## ARCHITECTURAL REVIEW COMMITTEE MEMORANDUM

SUBJECT: STACK FAMILY TRUST, OWNER FOR A MAJOR ARCHITECTURAL REVIEW APPLICATION FOR THE CONSTRUCTION OF A 4,122-SQUARE FOOT SINGLE-FAMILY HOUSE ON A HILLSIDE LOT LOCATED AT 2368 CITY VIEW DRIVE, ZONE ESA-SP PLANNING AREA, LOT 53, DESERT PALISADES SPECIFIC PLAN, SECTION 3 (CASE 3.4299 MAJ). (GM)

FROM: Development Services Department – Planning Division

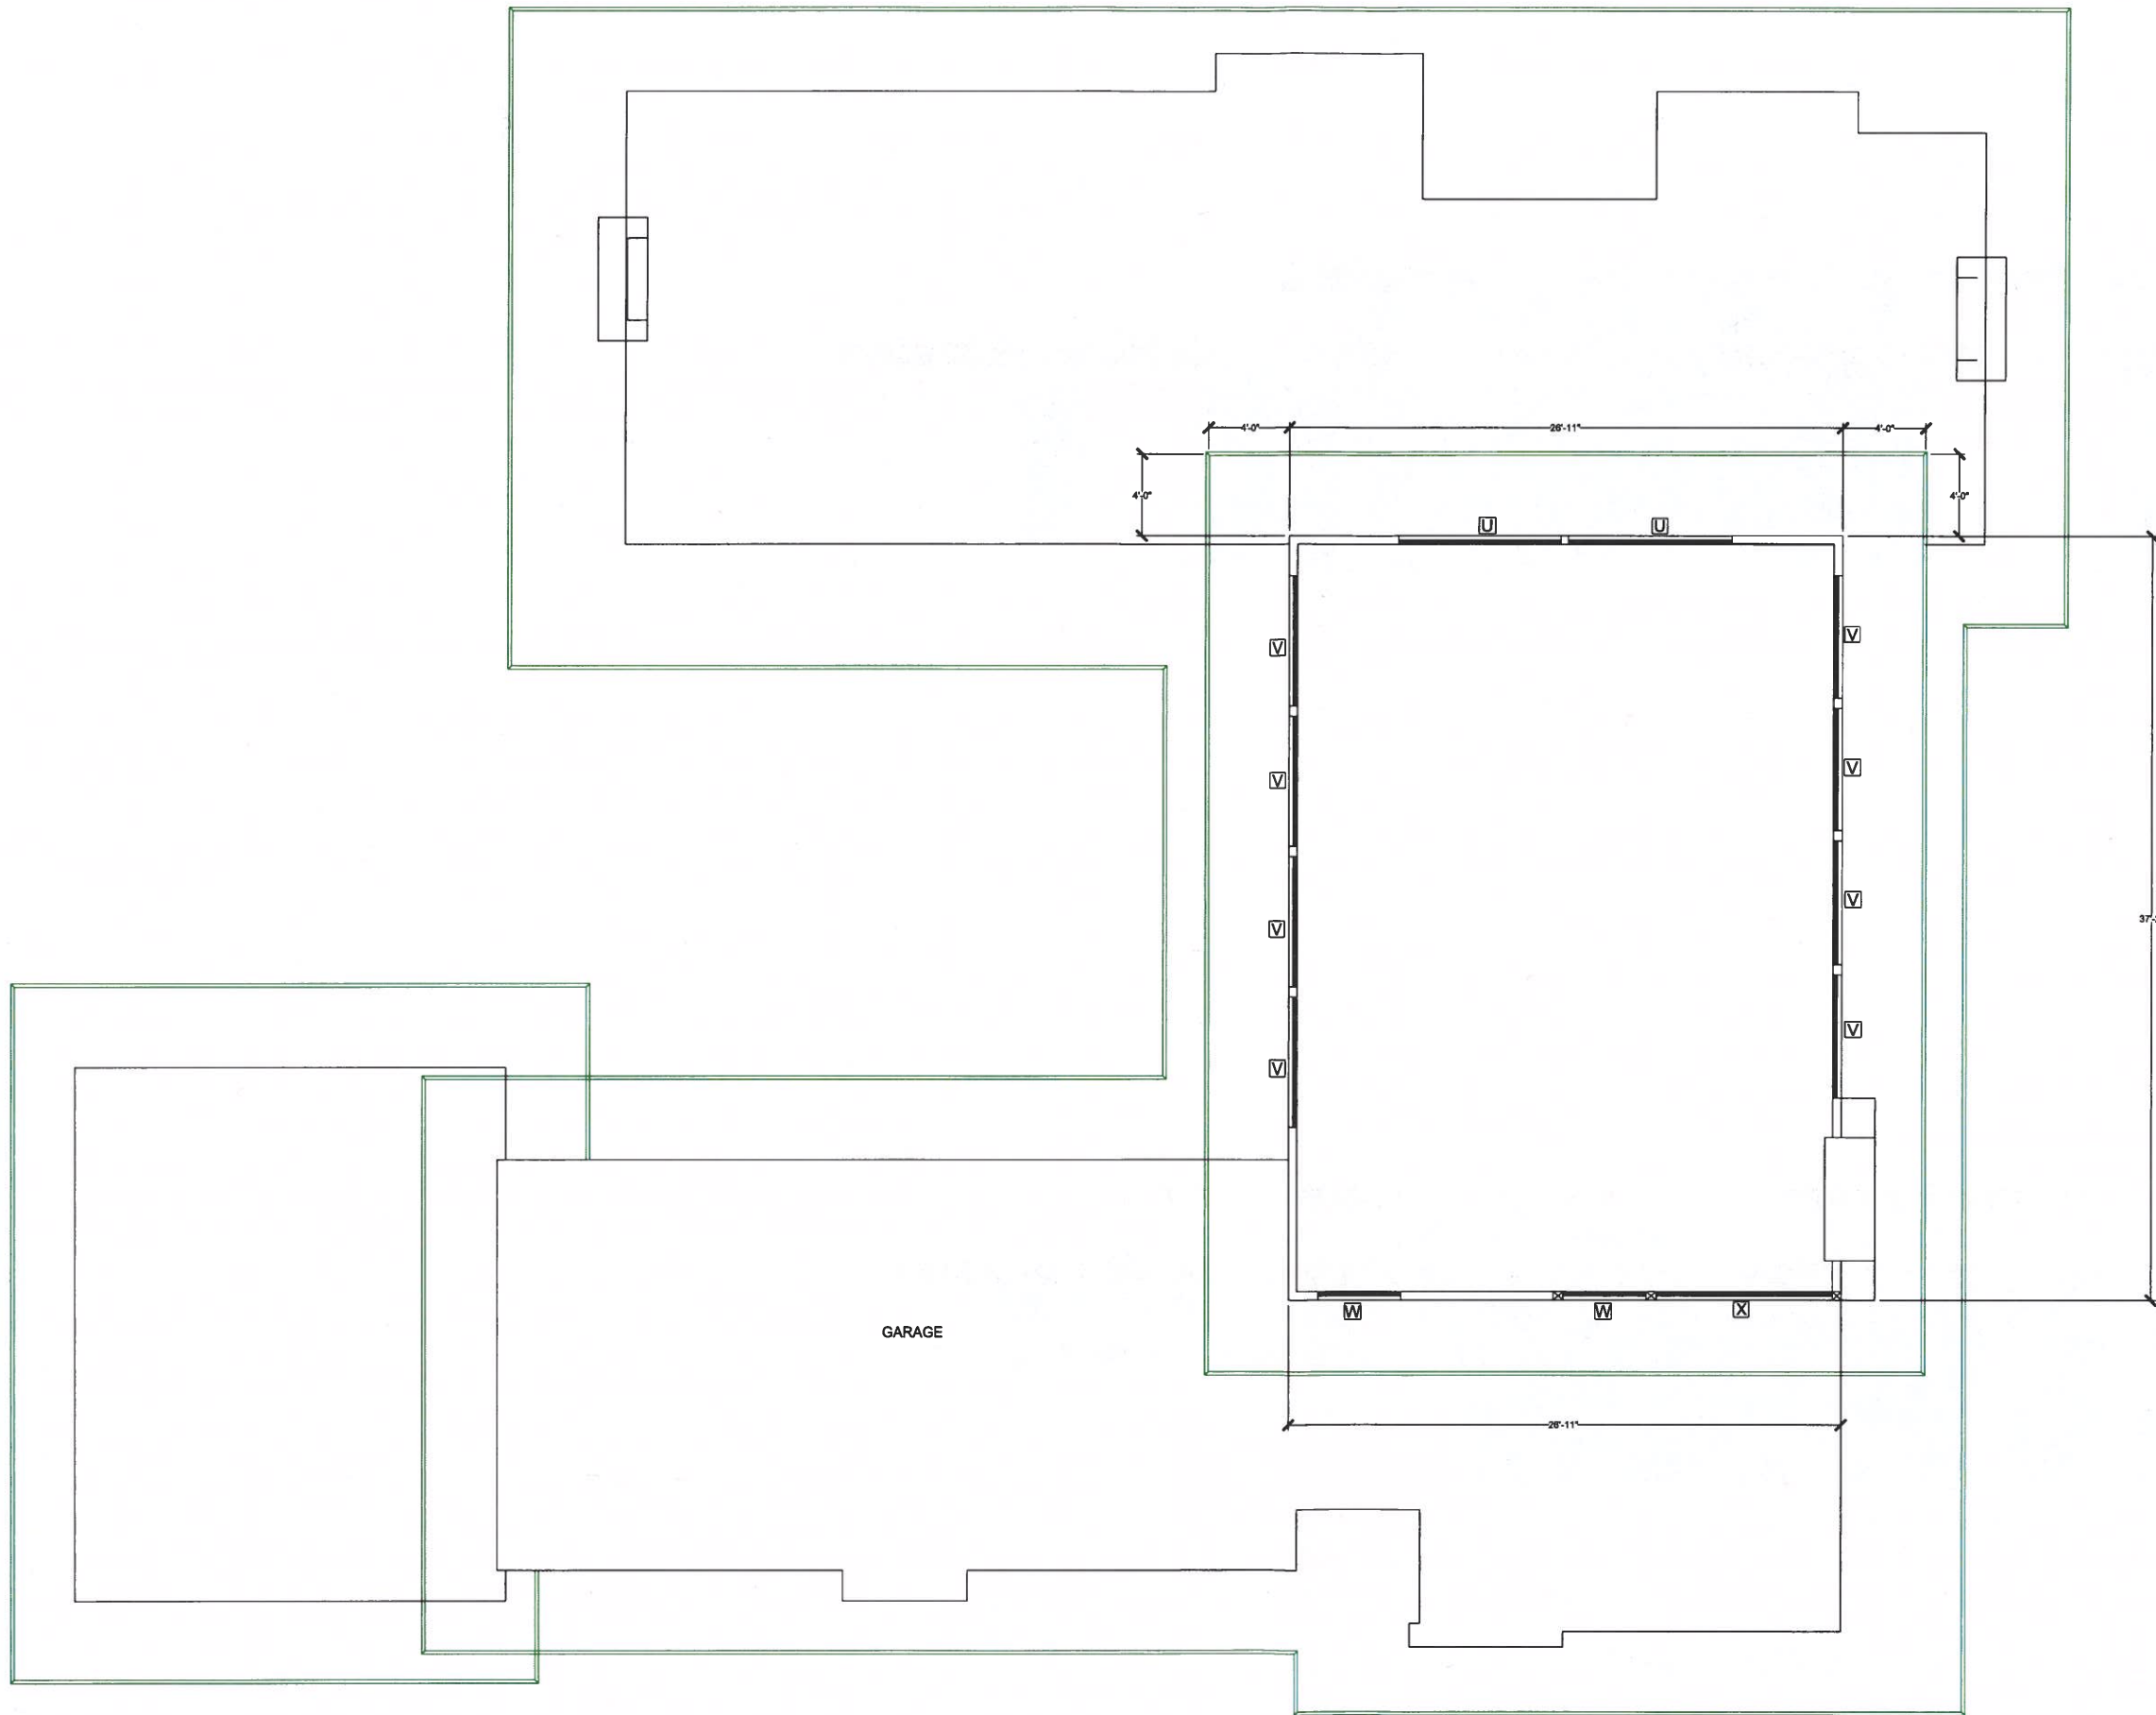
5. Exterior lighting plan re-evaluation number and types of light fixtures and eave lighting.  
*Revision: The landscape lighting plan has been revised to add path lights and address the number of fixtures and eave lighting specification is located on (A2).*

Member Lockyer thinks there will be a lot of boulders necessary to address the topography issues at both corners of the site. He said the ceiling lighting on sheet A-2 on the east side of the building does not appear to align with anything and will need to be revised. Further discussion was made on the placement of exterior lighting and the visibility of interior lighting from surrounding areas.

- Exterior lighting plan re-evaluation number and types of light fixtures and eave lighting.
- Landscape lighting Plan has been revised to address the number of fixtures and eave lighting specification is located on (A2)

**ROOF PLAN**

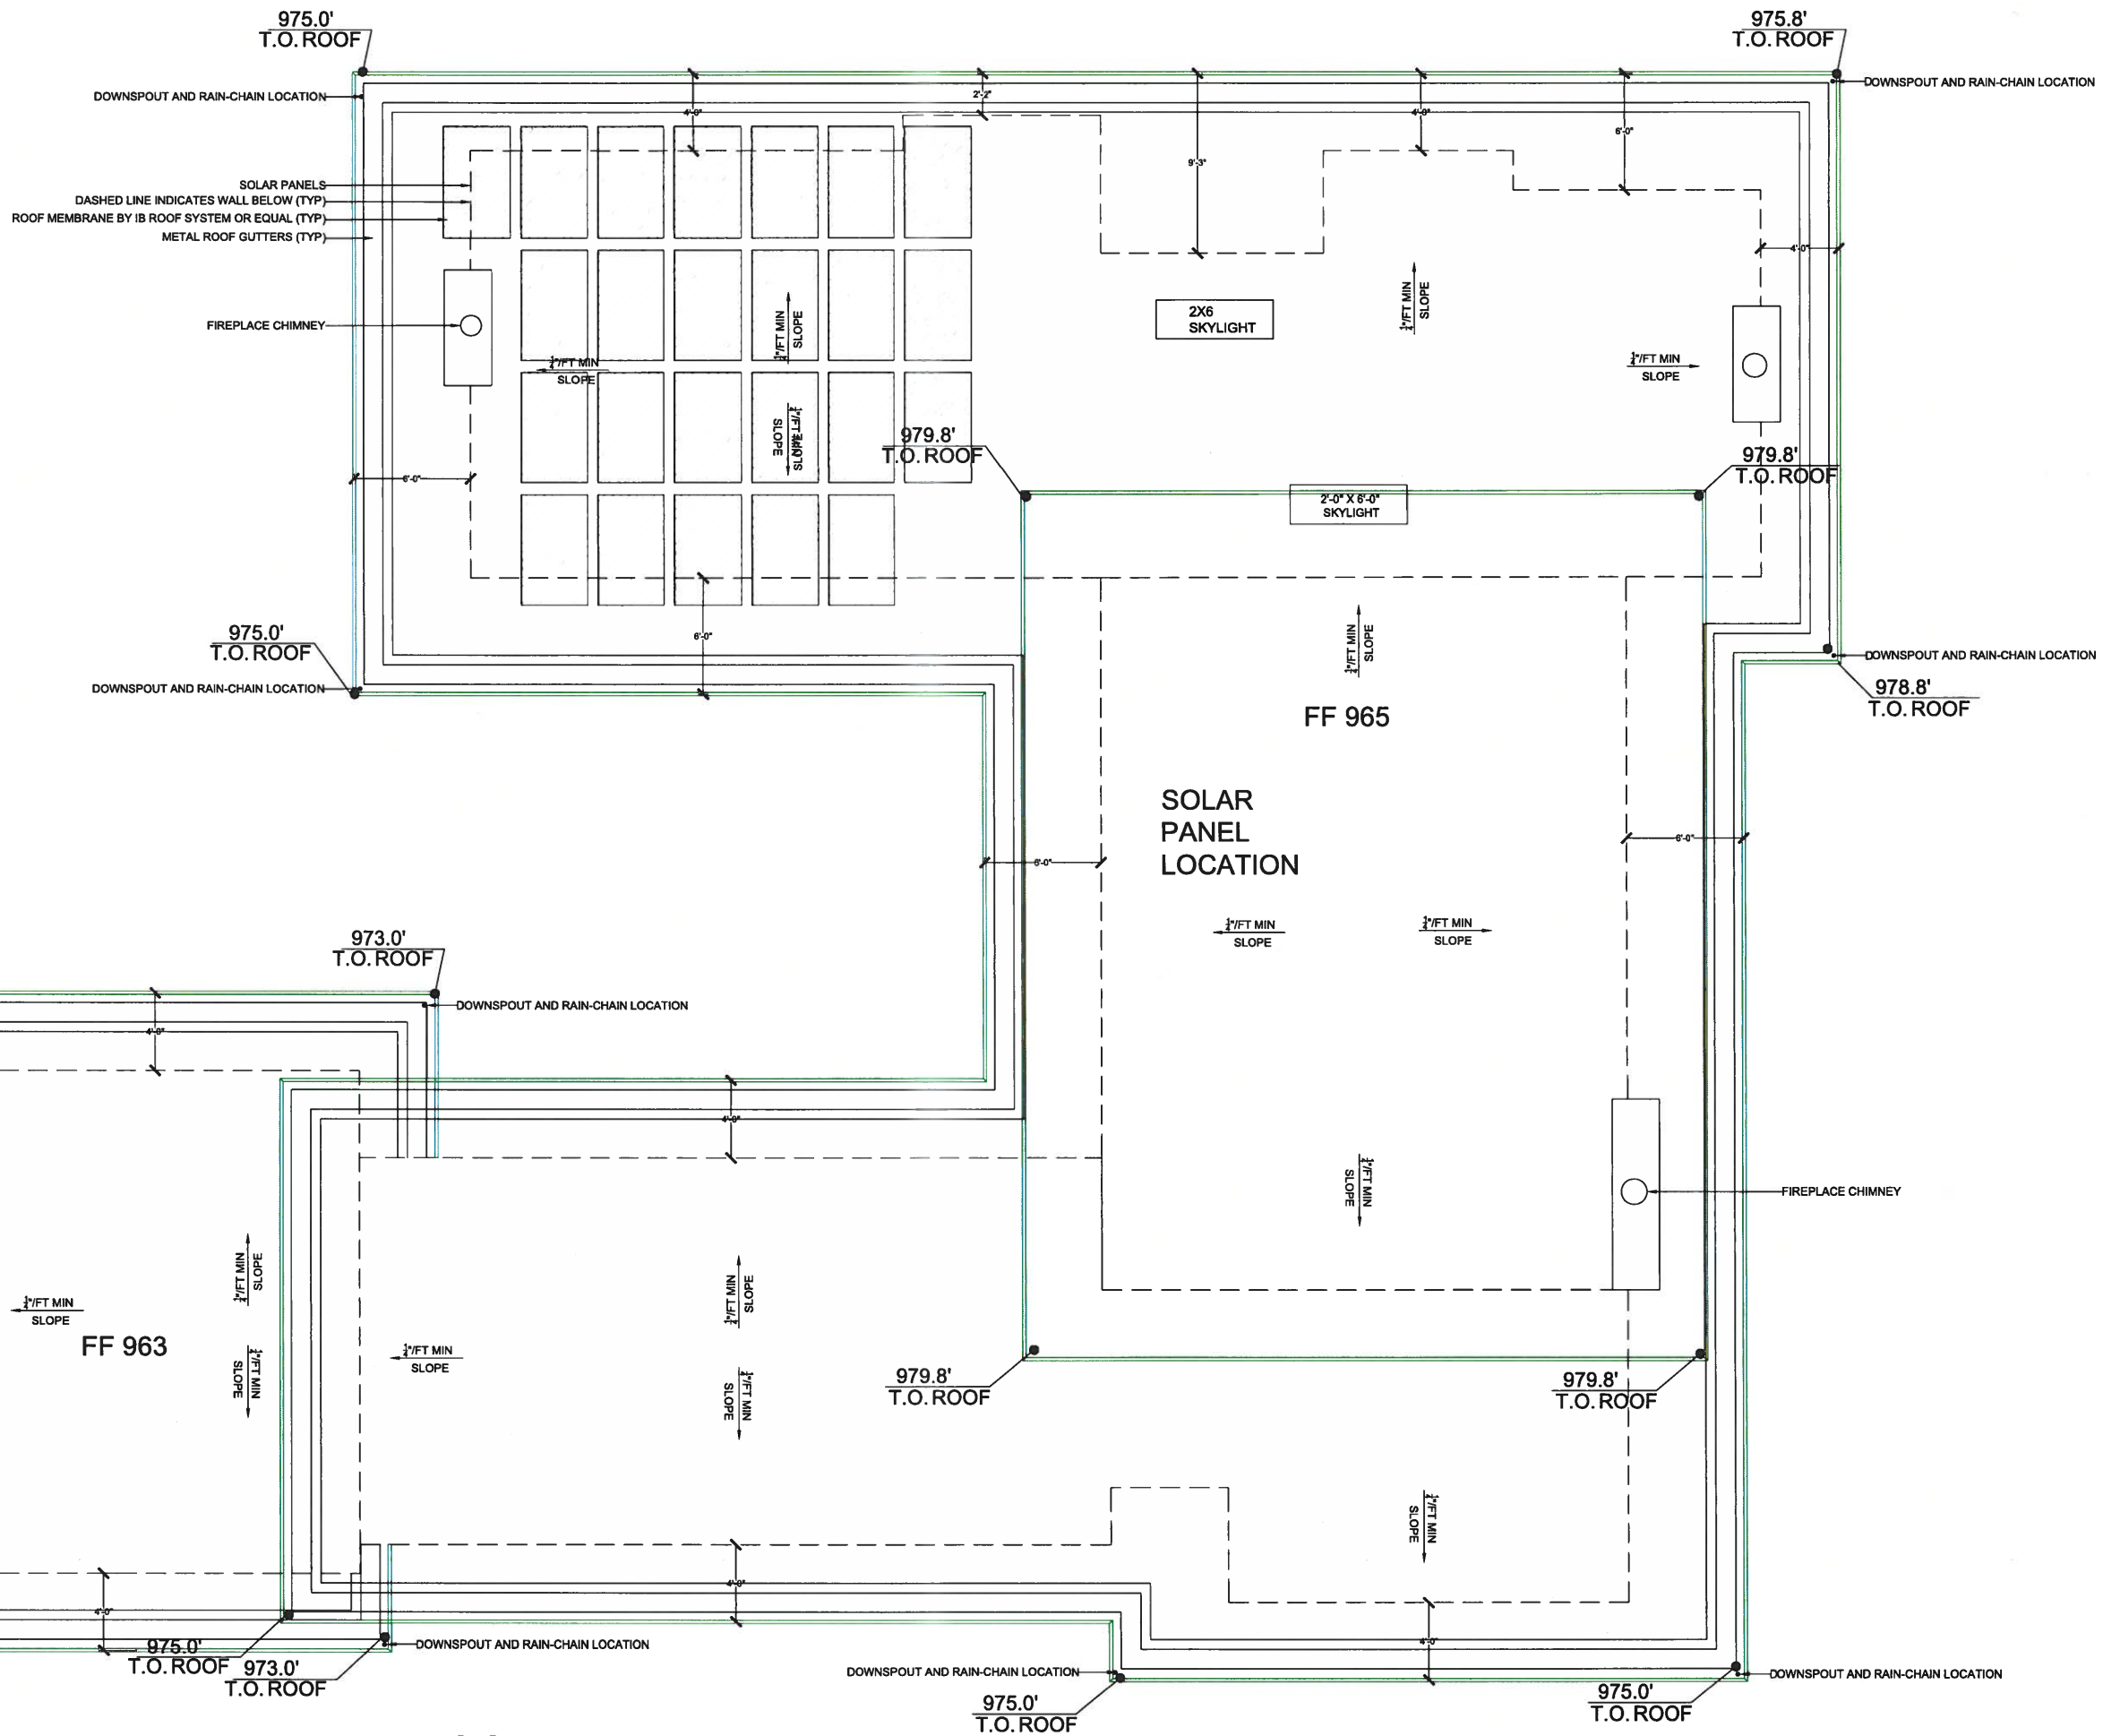
7. Roof plan to reflect solar panel placement and evaluation of fascia widths.  
*Revision: Roof plan has been revised to show solar panel placement and cross sections were added to show fascia widths.*

Chair Jakway asked that a roof section detail be provided to show the rafters and structural issues as they may affect recessed blinds and requested further details on the roof drainage and roof thickness.

- Roof plan has been revised to show solar placement and cross section added to show fascia widths
- List roof color on material board.
- Added to material board
